## **RE RESPONSE TO SUBMISSIONS ADEQUACY REVIEW – PROPOSED MANUFACTURING FACILITY AND ASSOCIATED WAREHOUSE – SSD 25725029**

### **PROPERTY AT: 657-769 MAMRE ROAD, KEMPS CREEK (LOT 10 APPROVED UNDER 9522)**

**TABLE 1. SUMMARY OF, AND RESPONSE TO, RTSCOMMENTS**

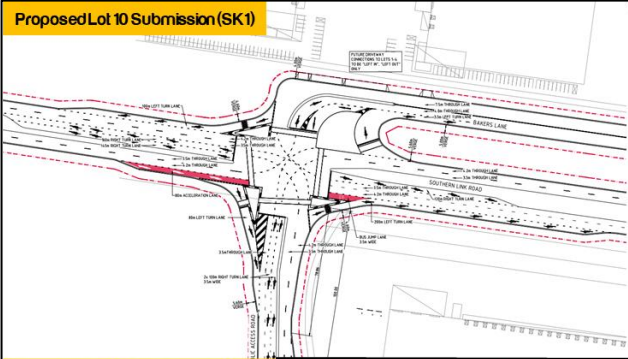
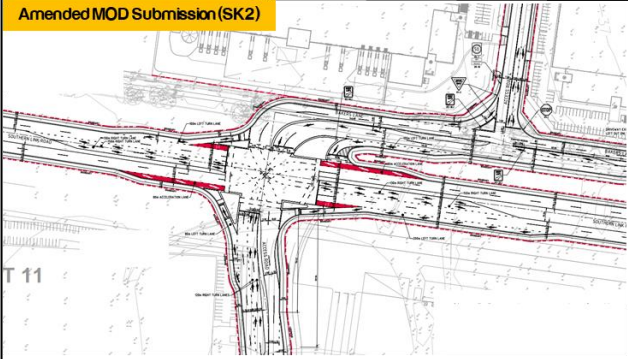
Comments	Response
<ul style="list-style-type: none"> <li>▪ The future SLR /Bakers Lane/NS Road 01 intersection design the proposal relies upon is not supported by TfNSW</li> </ul>	<p>Accordingly, the results of the assessments presented in this SSD are more conservative than what was undertaken for First Estate. This conservative approach provides flexibility for later developments to reflect minor changes that may occur over the life of the MSP.</p> <p>Therefore, it is our opinion that the TfNSW suggested MRP trip generation rates are considered even more conservative than the above rates and exceed the surveyed trip generation rates. Therefore, the above rates are more suitable for the purpose of this assessment.</p> <p>Notwithstanding, with the adoption of the 0.247 trip rate during the AM peak hour, the resulting traffic generation of 1,091 veh/hr is greater than the traffic generation for the MRP suggested rate of 0.23 and 0.24 veh/hr. Therefore, traffic modelling done with these rates already suggests a level of conservativeness that is beyond the suggested MRP rates.</p> <p>It is noted that the amended design advice from TfNSW (sent on 3 Nov 2021) for the future SLR / Bakers Lane / NS Road 01 was provided to Ason Group after the intersection layout had already been modelled and analysed in SIDRA as part of the original Lot 10 submission. In this regard and as part of the consultation with TfNSW for a separate SSD-9522 Modification (MOD 3), the design of the intersection layout was amended as shown in the figure below.</p>

Comments	Response
	<div><div>Proposed Lot 10 Submission (SK1)</div><div>Amended MOD Submission (SK2)</div><div>As TfNSW requested that the design for this intersection be amended, the SIDRA layout was amended as well. Notably, the phasing (double diamond), cycle time (140 seconds) and traffic volumes have not changed from the initial intersection layout design shown within the proposed Lot 10 SSDA TA. A summary of the SLR / Bakers Lane / NS Road 01 SIDRA results (for the SSDA TA layout) is shown below:</div><div></div></div>
